B.7 Indonesia, Aceh (2005) - Steel frame

Plans and comments

Ground floor plan

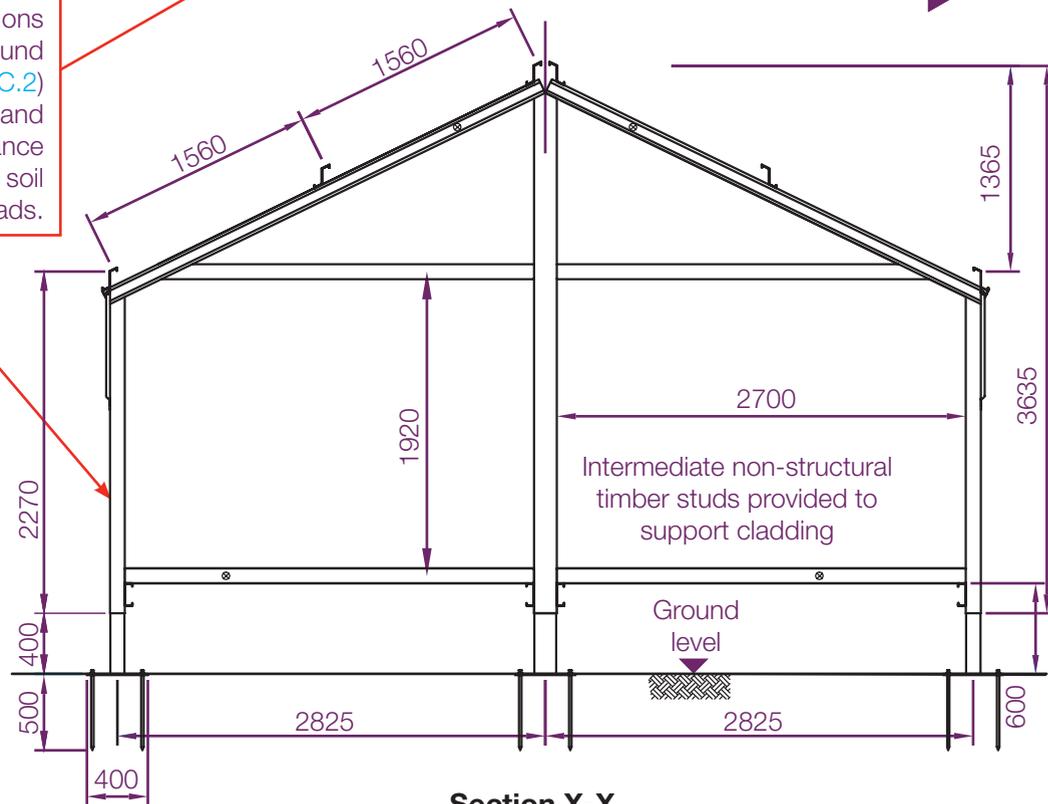
CHECK: In areas known to have high local wind pressures adequate foundations and member sizes must be provided.

CHANGE : Modify the foundations from base plate nailed to the soil to concrete pad foundation ([Section C.2](#)) depending on soil type to prevent settlement of shelter.

CHANGE: Use base plate or foundations or screw in ground anchor ([Section C.2](#)) to increase uplift and sliding resistance depending on soil type and wind loads.

CHANGE: All column sizes should be increased in accordance with design to local wind pressures.

Section X-X

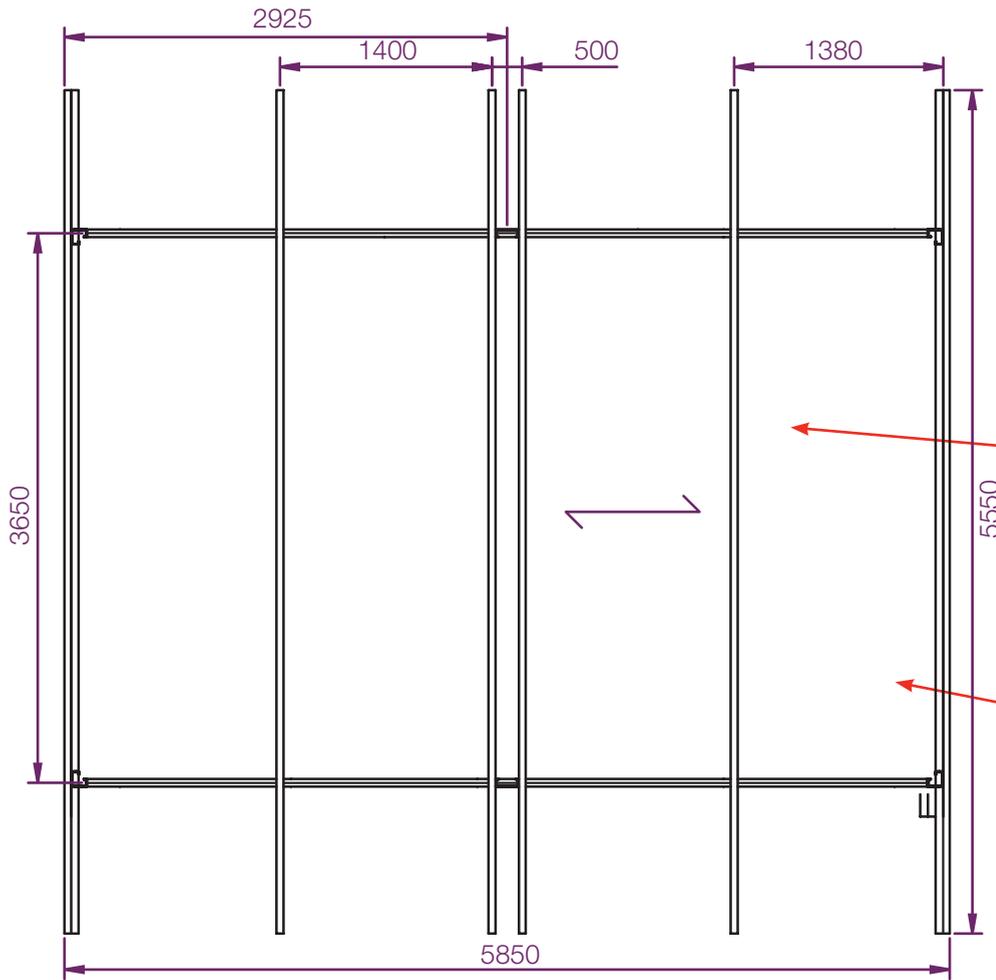
CHECK: The design and detailing of all connections is critical to the stability of the structure and should be checked for individual cases.

CHECK: Fasten roof sheet to purlins using screws spaced at appropriate intervals (Section C.4).

CHANGE: Provide in-plane bracing in the roof to increase lateral stability.

Roof Level Plan

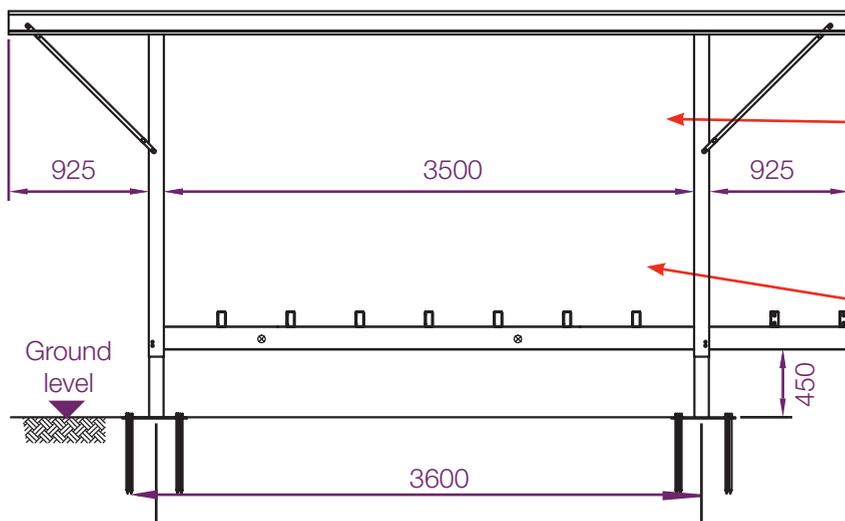
CHANGE: Improve lateral stability by nailing planks to each other (Section C.3.2) upgrading the walls using 1/2" thick plywood (plywood 1 annex I.1.3) with vertical framing spaced at 600mm and the plywood with maximum 150mm on centre nail spacing (Section C.3). In this case header and primary floor beams would also require strengthening. Alternatively, walls could be braced in-plane with diagonal steel bracing.

CHECK: Do not upgrade walls using masonry or cement blocks due to risk to life and increase in seismic force attracted to the structure.
